SITE PLAN REVIEW

LOT NO. 10 REGISTERED PLAN 434-2017

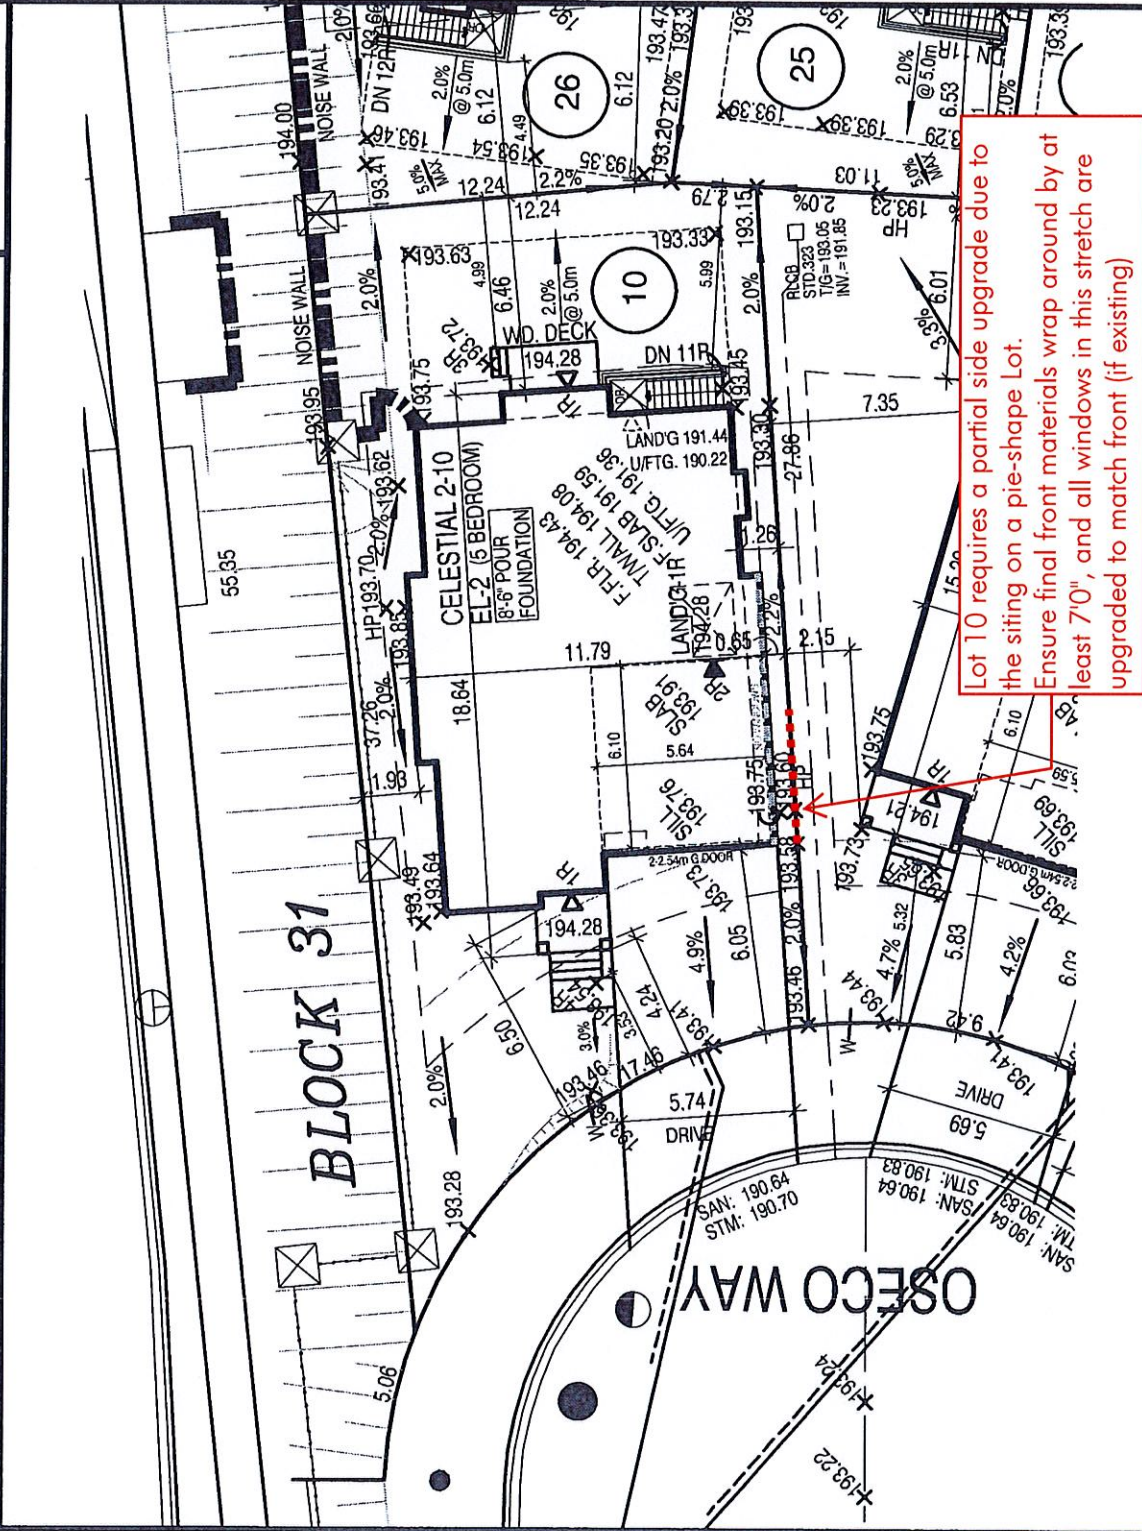
THE PROPOSED LOT GRADING AND DRAINAGE IS APPROVED AS BEING IN CONFORMITY WITH THE OVERALL APPROVED GRADING PLANS FOR THE SUBDIVISION

NO COMMENT ☒ REVIEWED BY [Signature]
